PROJECT: VT RT 9, BRIDGE NO. 11
 TOWN OF WOODFORD, VT
 OVER WALDOOMSAC RIVER

TITLE: INTERMEDIATE SUPPORT AT WATERLINE

REFERENCE: PROJECT NO. ER BHF 010-1 (44)

5 - INTERMEDIATE SUPPORT 111CF1

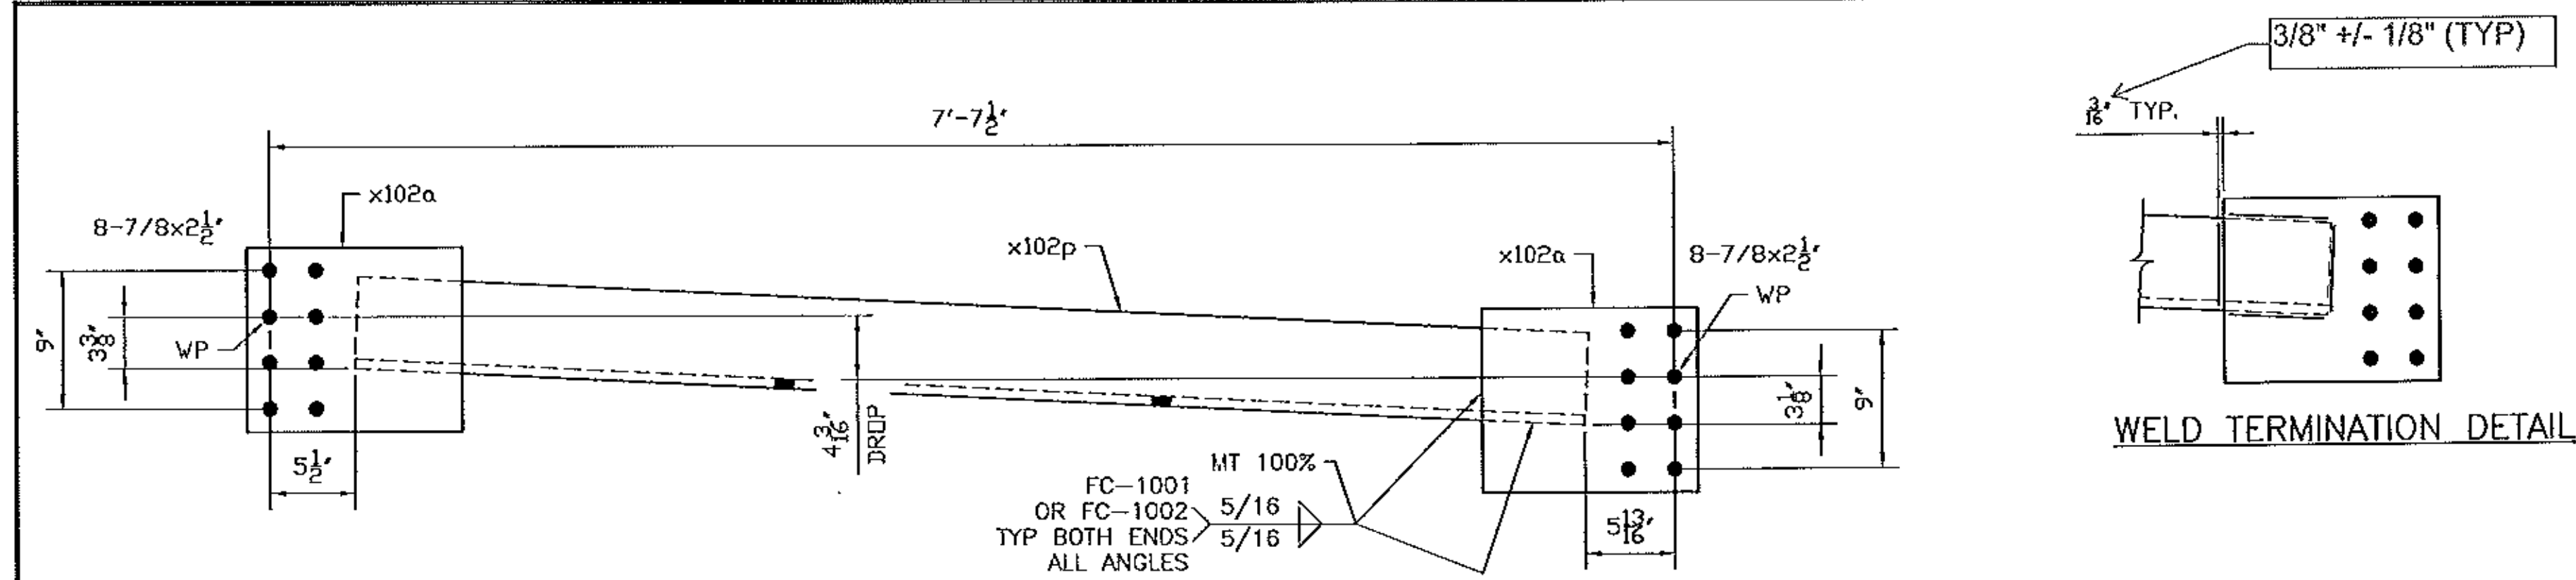
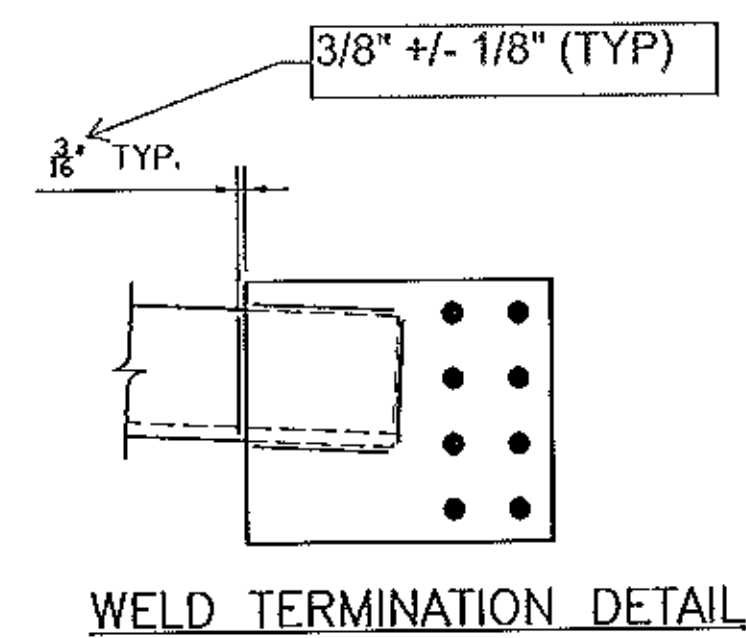
See standard specification 506.24(a)(9), no payment will be made for bolts, nuts, washers, they are considered to be incidental
